City of
Richmond

Report to Development Permit Panel

File: DP 11-566011

Re: Application by Omicron Architectural Engineering Construction Ltd. for a
General Compliance Ruling at 15111 Williams Road and Richmond Key 195105

ATTACHMENT 2: Overlay Plan Showing The Existing And Proposed Pierson Road Alignment

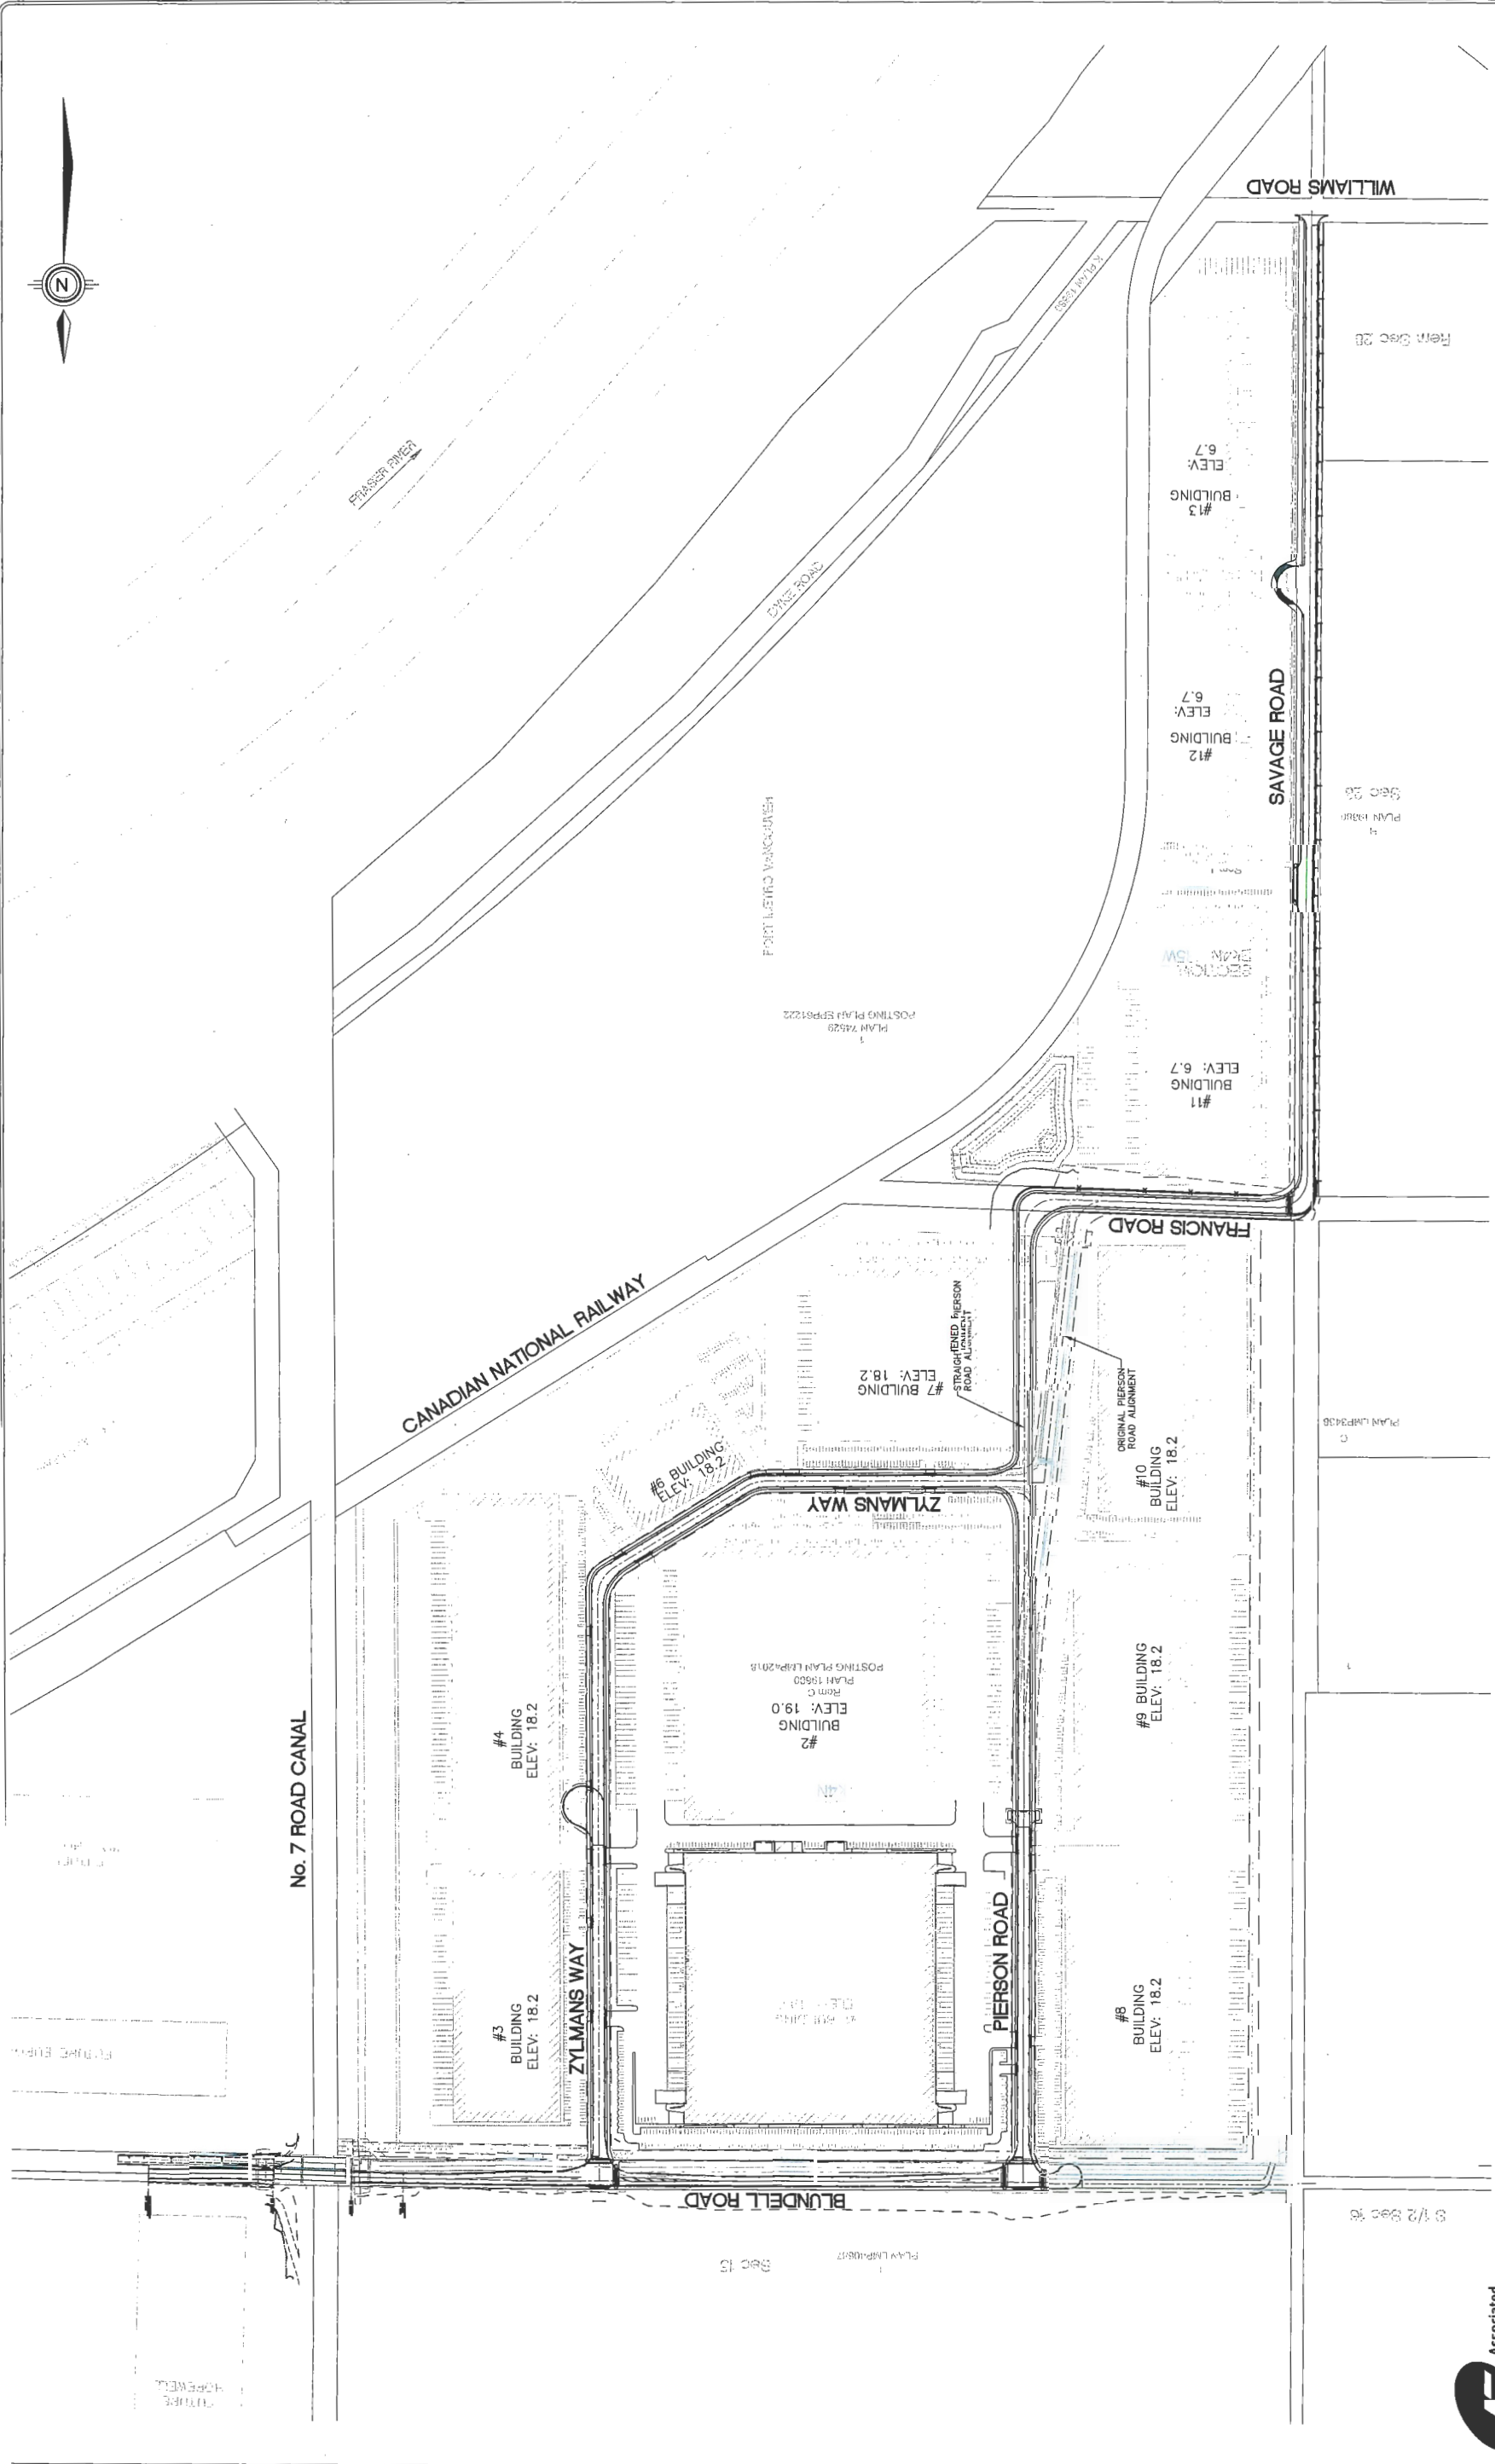
1. Straightening Pierson Road by shifting the southern end approximately 40 m to the east (Attachment 2). Modifications to the statutory right-of-way (SRW) legal documents and the related Servicing Agreement plans (SA13-641028, SA14-677209, SA16-737220) will be required to reflect the change in alignment and the associated works (e.g. frontage improvement relocations, fill adjustments, off-site landscaping, etc.).

The proposal involves moving the southern end of Pierson Road approximately 40 m to the east; allowing for a straightening of Pierson Road between Blundell Road and Francis Road. See Attachment 2 for an overlay showing the existing and proposed Pierson Road alignment. The rationale for straightening Pierson Road is to allow for more efficient use of the land base. Building footprints and parking layouts for the proposed developments adjacent to Pierson Road, particularly for areas in vicinity of buildings #2, 7, 9 and 10 (as shown on the Development Phasing Plan in Attachments 3 and 4), will be significantly improved with the more regular lot shapes. Neither Engineering staff nor Transportation staff have concerns with the Pierson Road realignment and these roads will be reviewed through amendments to the current Servicing Agreements.

Plan #3

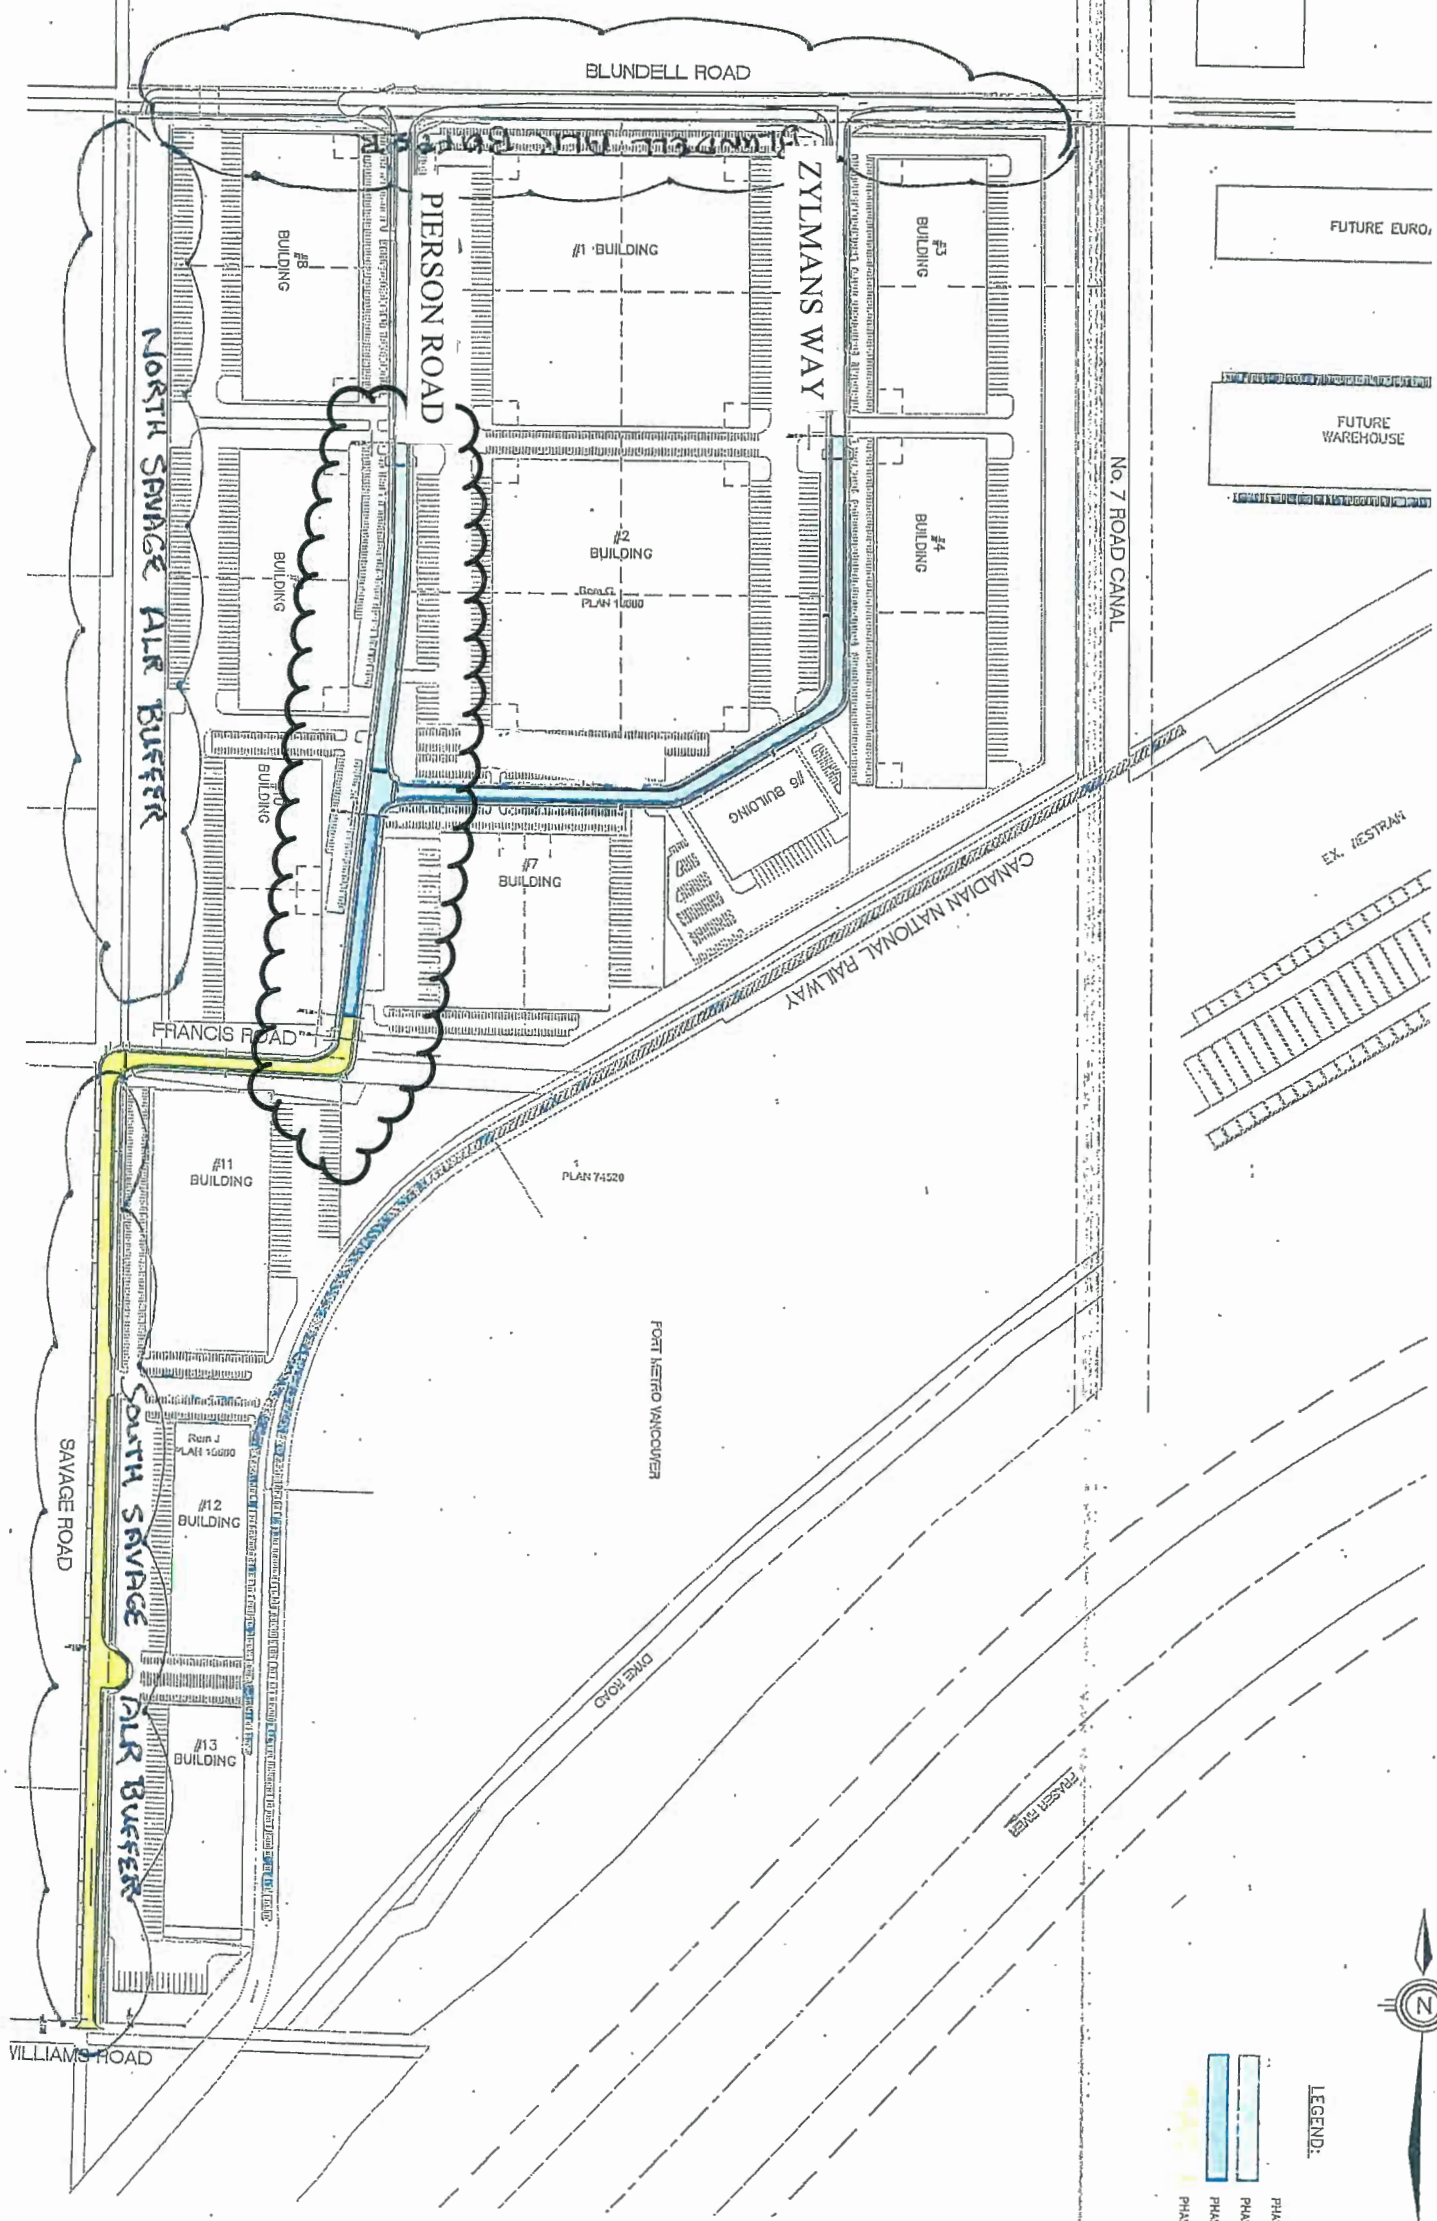
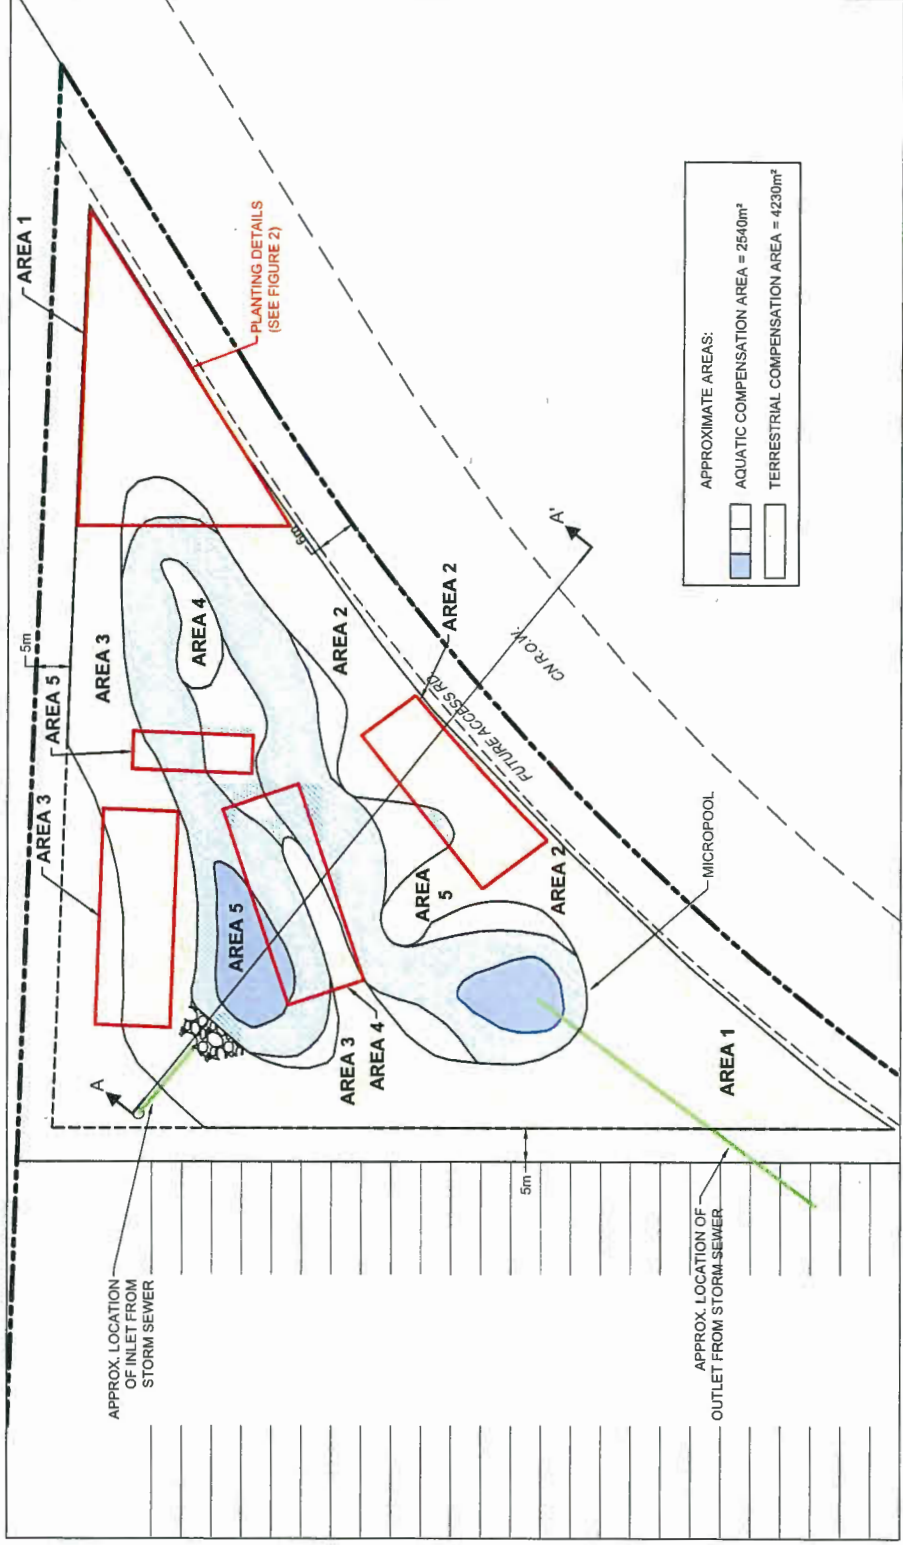
Additional Plan added, Adjusted current plan to 3a and added 3b for the wetland.
